## Roads Department – Planning Report

### Additional Information Requested by SDCC:

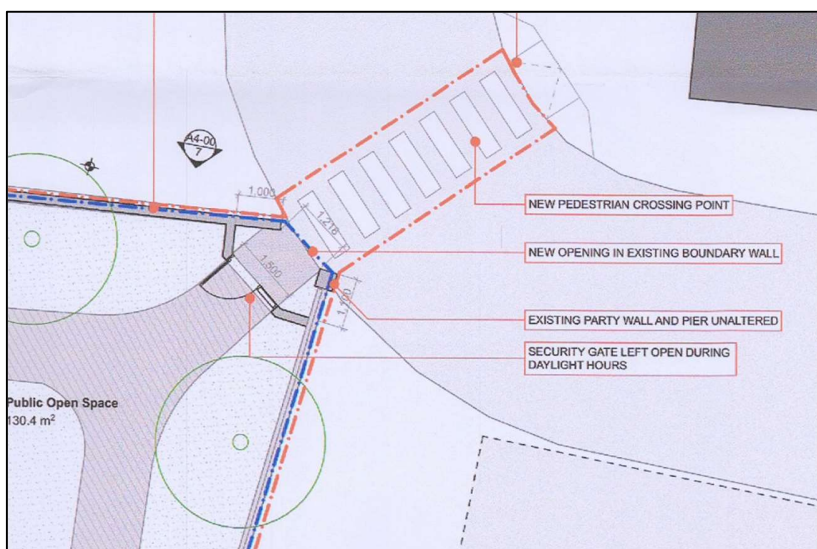
The applicant has provided a traffic analysis for the junction with Tay Lane and the Rathcoole Main Street. The analysis shows that the development will have a sub threshold impact on the road network at below 5%, but the applicant completed the analysis for comprehensiveness. The over all results from the analysis shows a 2% impact traffic increase on the junction. The analysis for the other arms of the junction have not been reported, the main street arms C-A, A-B and A-C. This is required as a 2% increase to a junction that is showing signs of been congested may led to problems. The applicant is requested to supply the Max RFC's for the other arms of the junction.
